PW2 - Proposed Level 15 Plan

Project: Player Wills
Location: Former Player Wills Site, South Circular Road, Dublin 8
Client: CWTC Multi Family ICAV

Drawing Title: PW2 - Proposed Level 15 Plan
Drawing No.: 25068-OMP-PW2-15-DR-A-1015

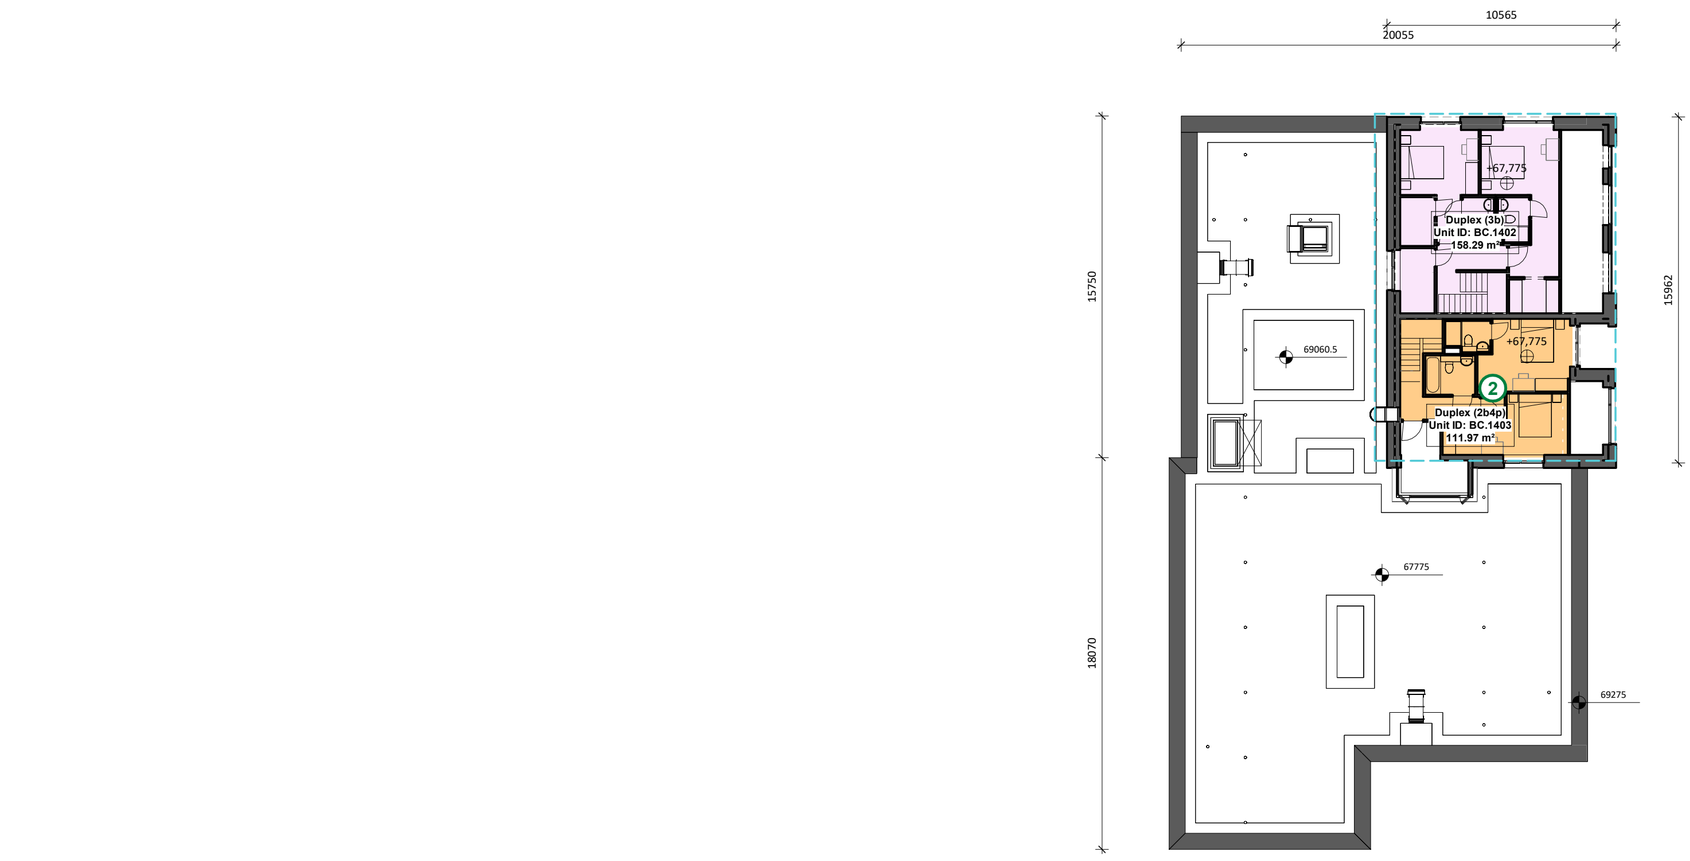
1. Provision of a second stair in accordance with updated Building Regulations (TGD Part B), with associated reconfiguration of layouts.
2. Permitted duplex unit changed from 1-bed to 2-bed
3. 2-bed changed to 1-bed to facilitate requirement for second stair to comply with new fire regulations
4. Permitted 1-bed duplex unit is reconfigured as 1-bedroom apartment.
